MYO MONITORING REPORT

Swamp Grape Stream and Wetland Mitigation Site

Response to DMS Comments – Draft Baseline Document (MY0) and As-built Drawings
DMS Project No. 100115
Full Delivery Contract No. 7869
DMS RFP No. 16-007705
USACE Action ID No. SAW-2019-00904
DWR Project No. 2019-0675

Comments Received (Black Text) & Responses (Blue Text)

Preconstruction (2021 Data)

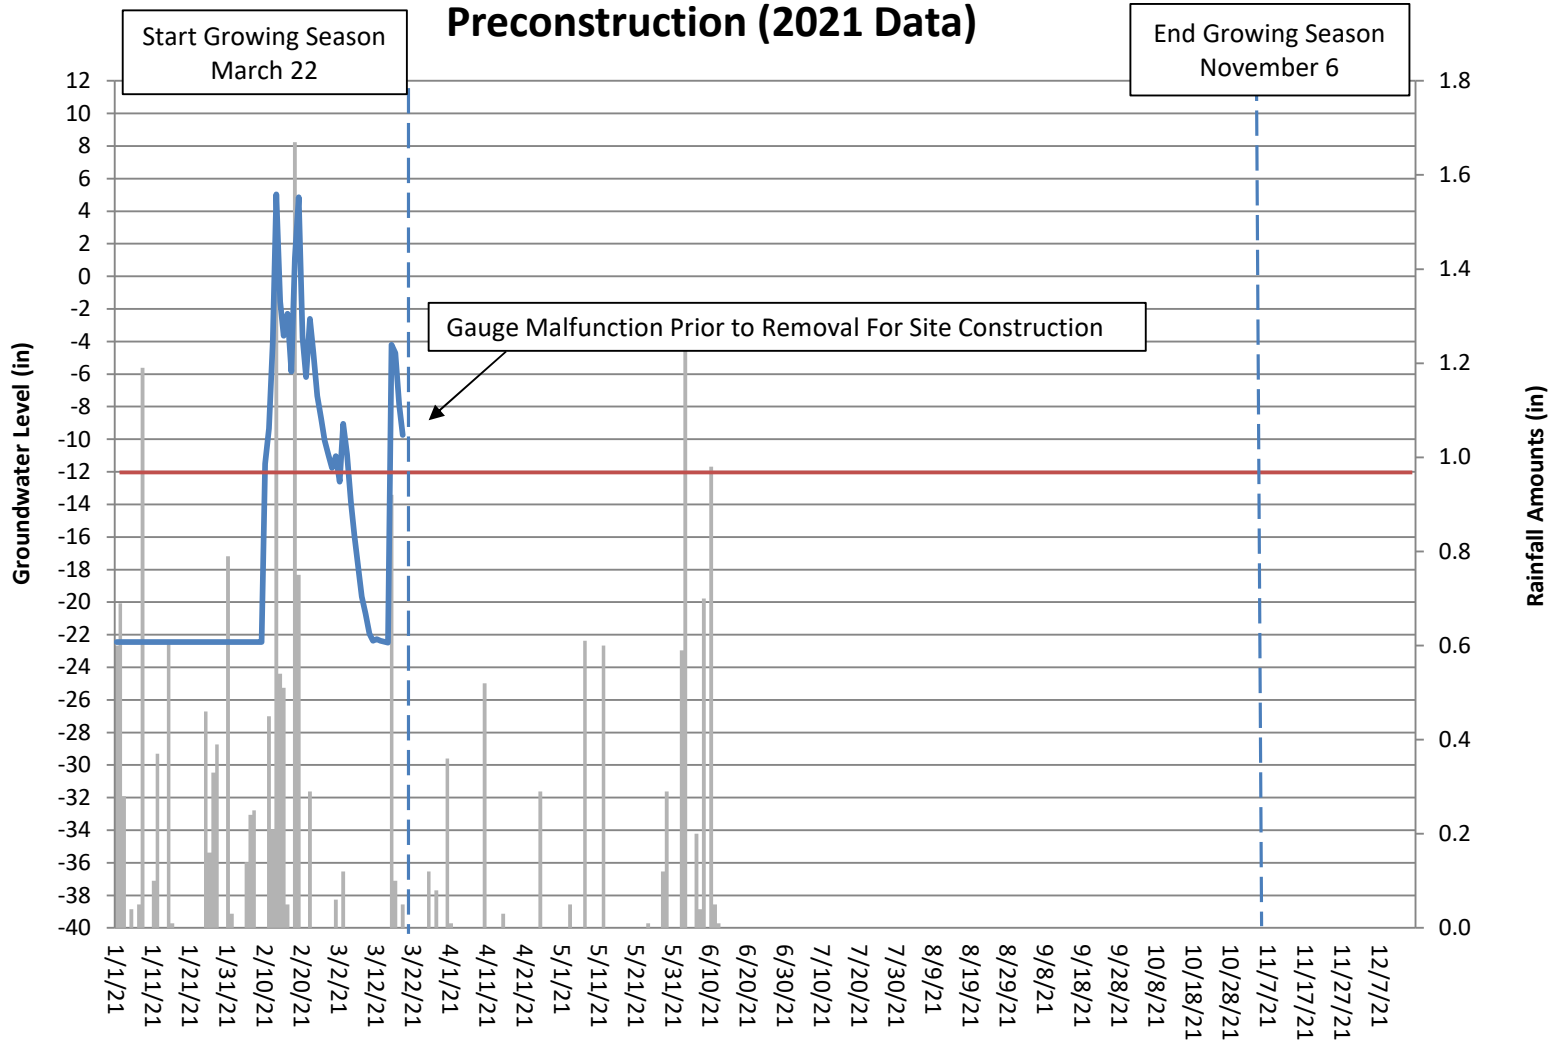
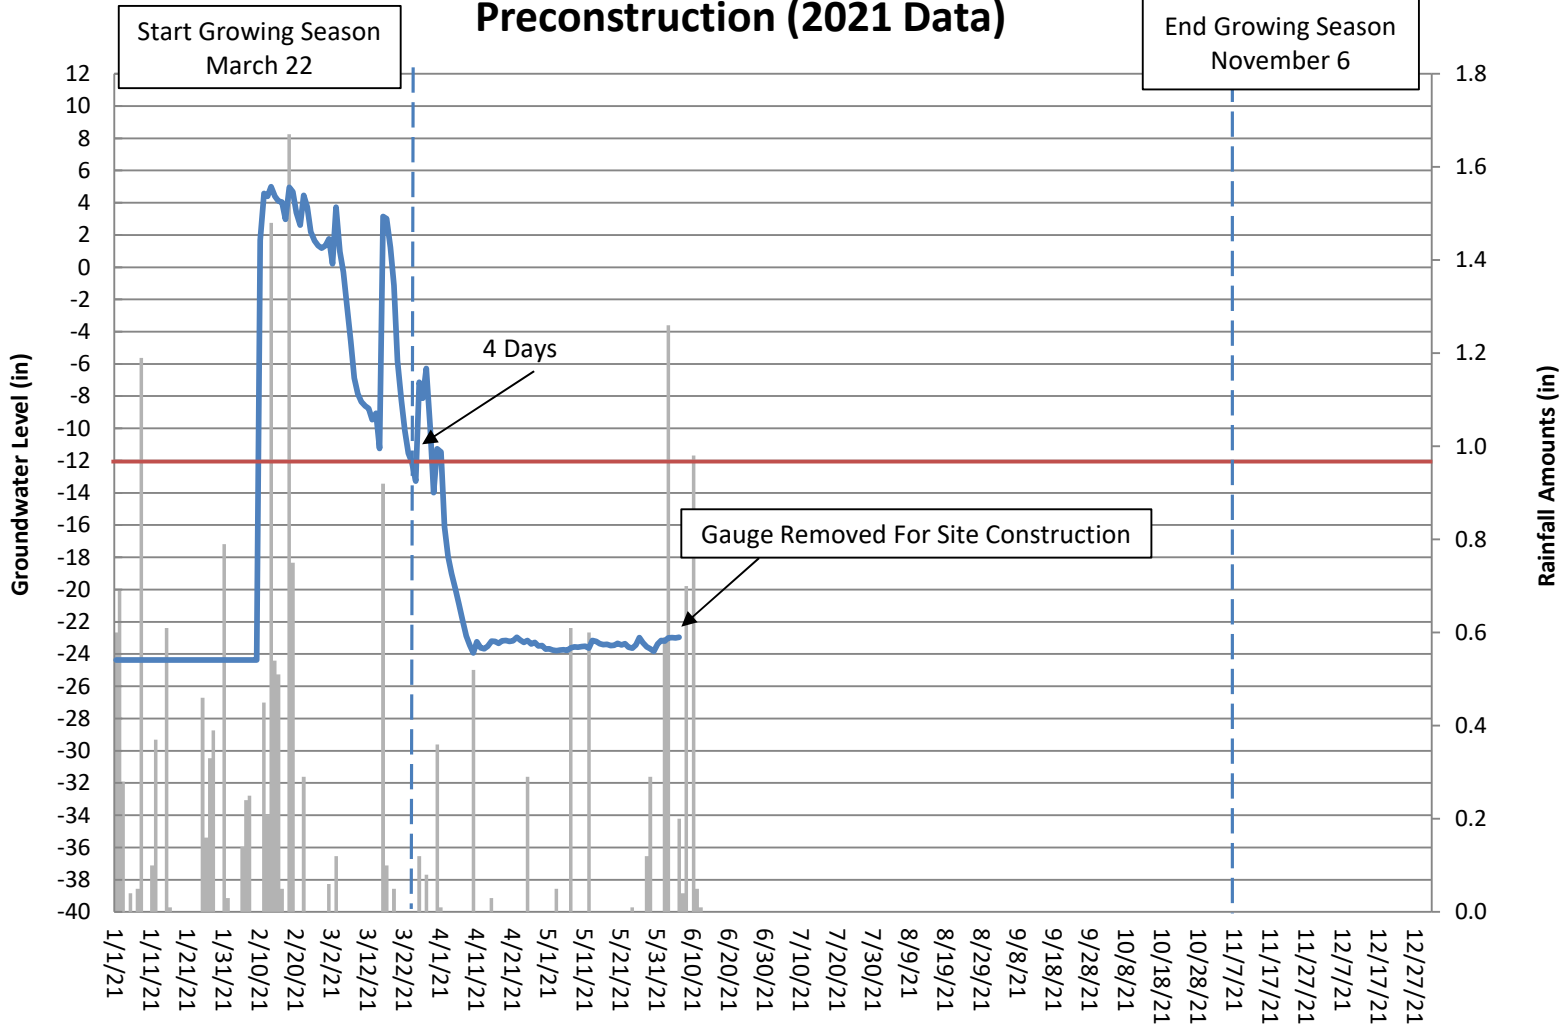
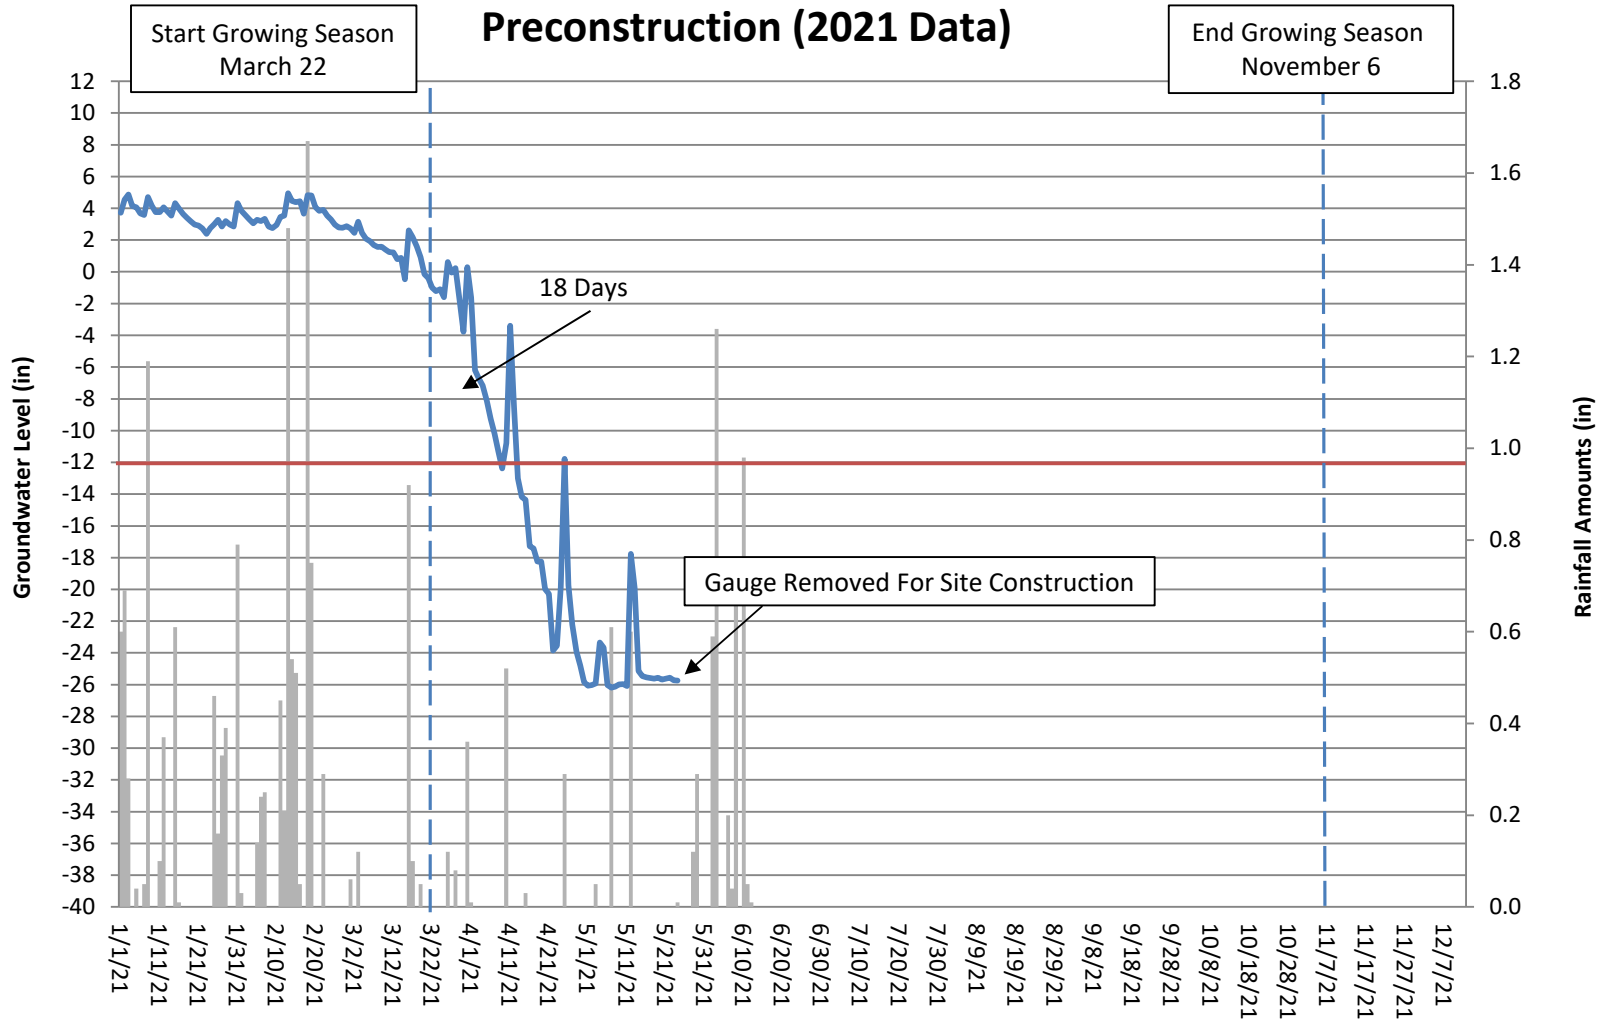
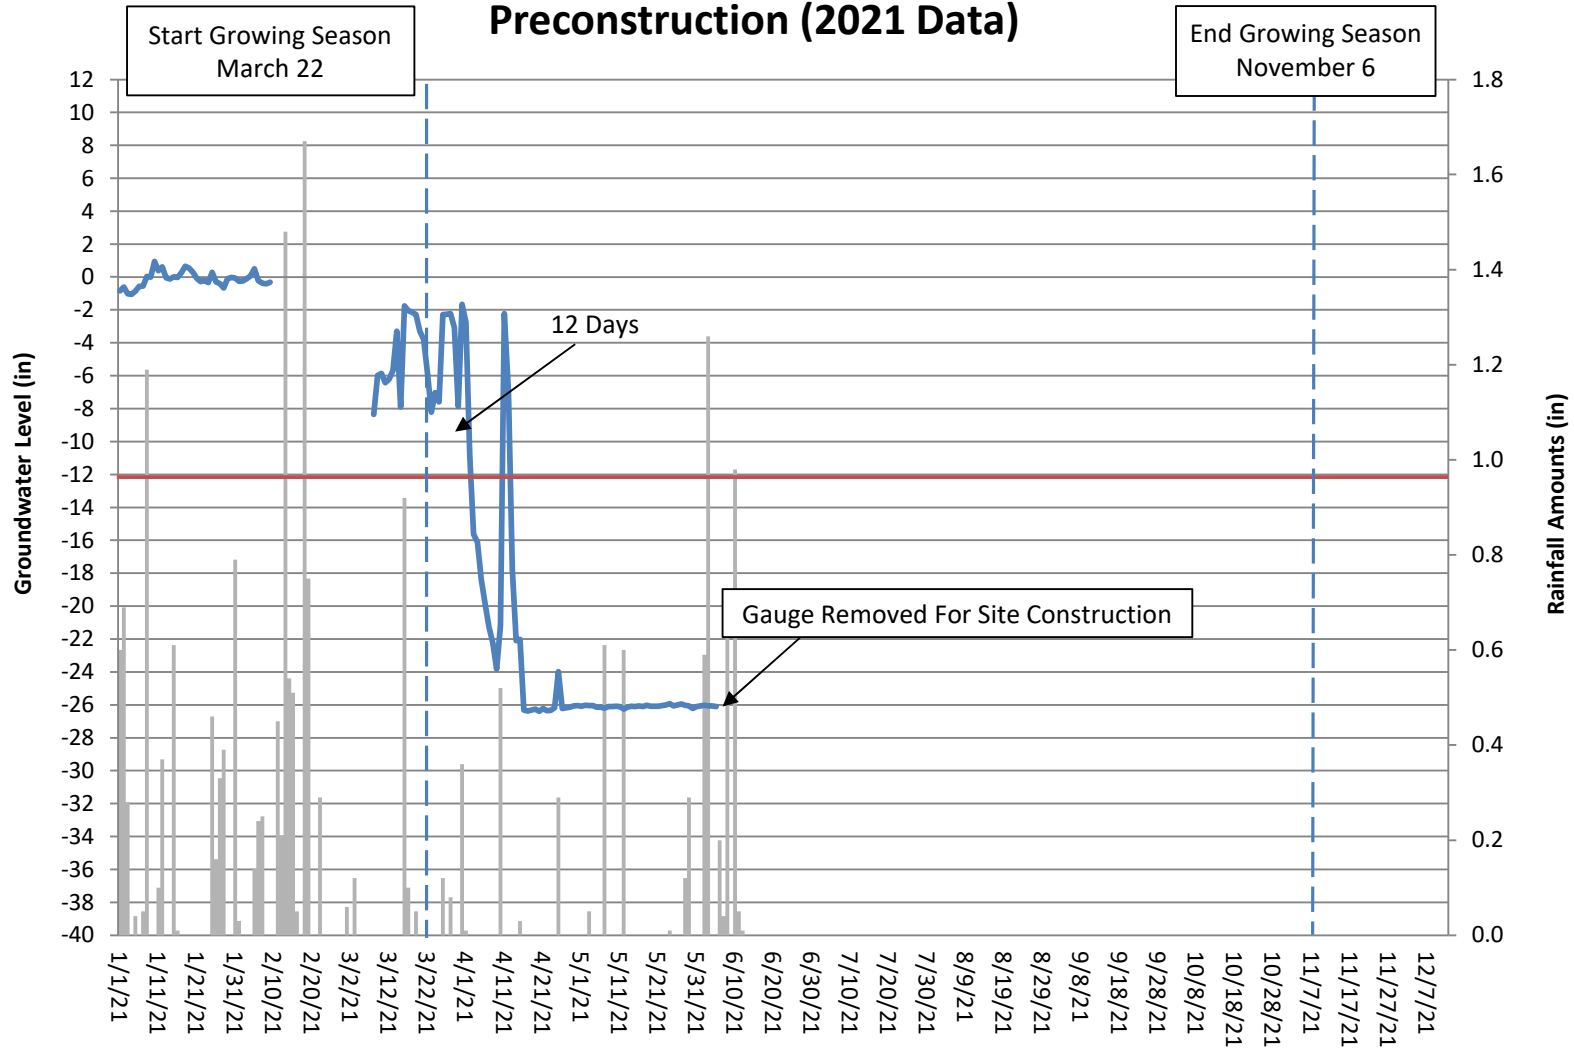
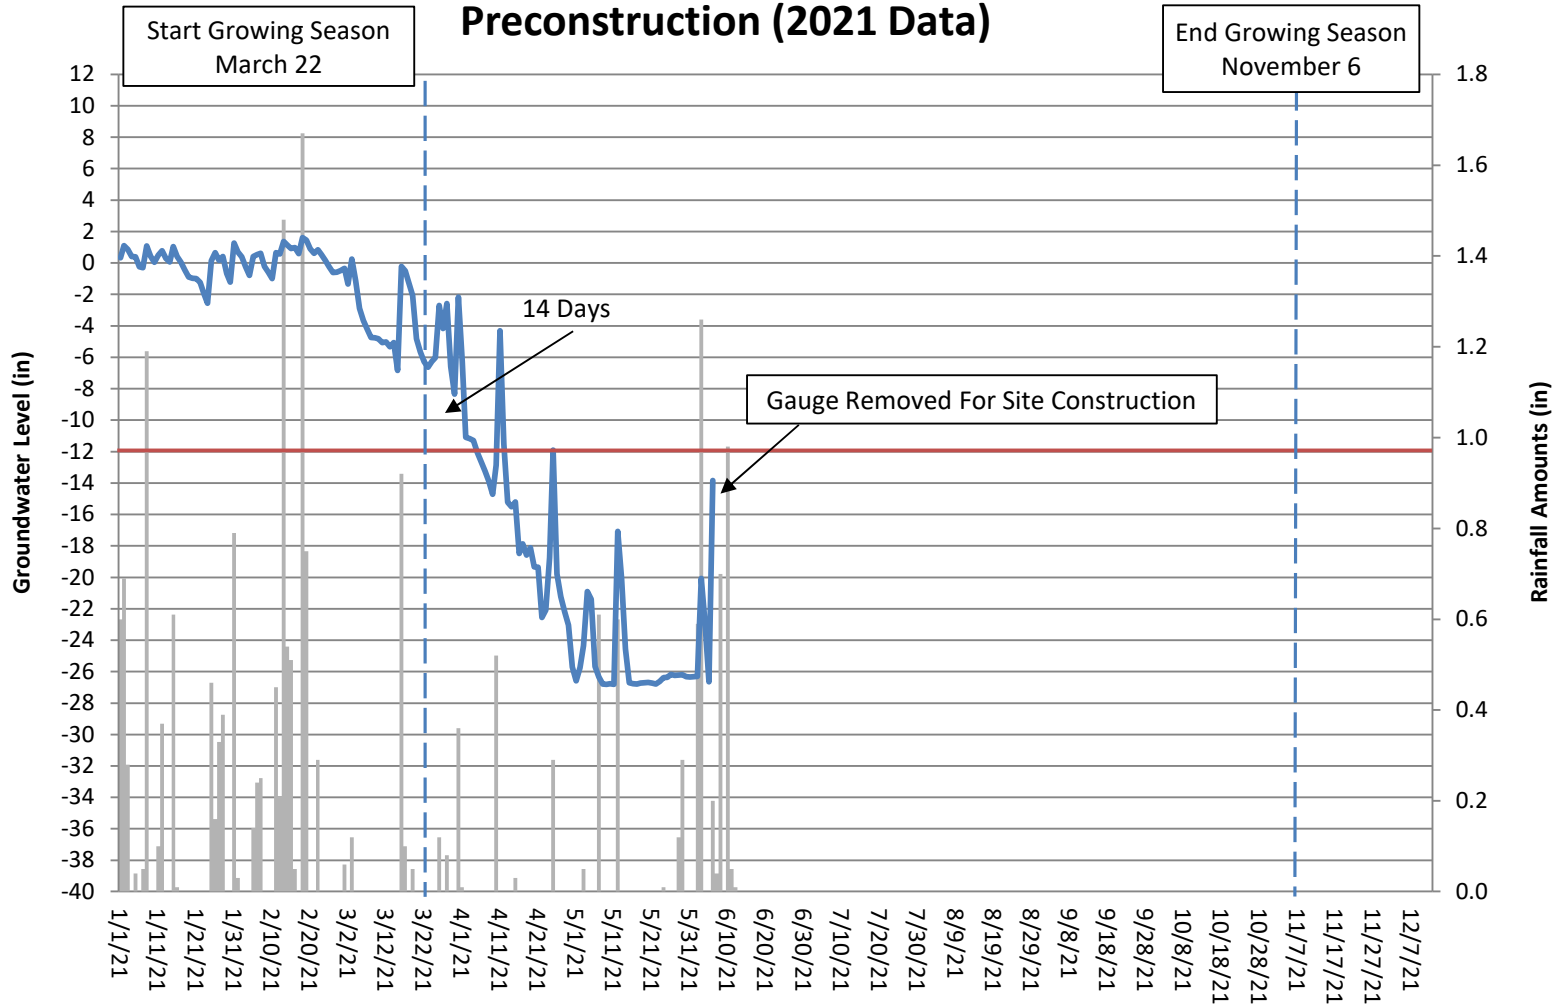
1. Cover pages: check USACE ID no; DMS has 2019-00904 in its records.
Response: The USACE ID was corrected to 2019-00904.
2. Present the 2021 pre-restoration groundwater gage data in the MY0 report.

Response: We have included the 2020 and 2021 pre-construction groundwater gauge data in Appendix D.
3. In the field, we discussed that the pre-restoration gages numbers were not the same as post-restoration gage numbers. Provide a map of the pre-restoration gage locations and numbers. It may be useful to provide a discussion of the 2020 and 2021 data for context.
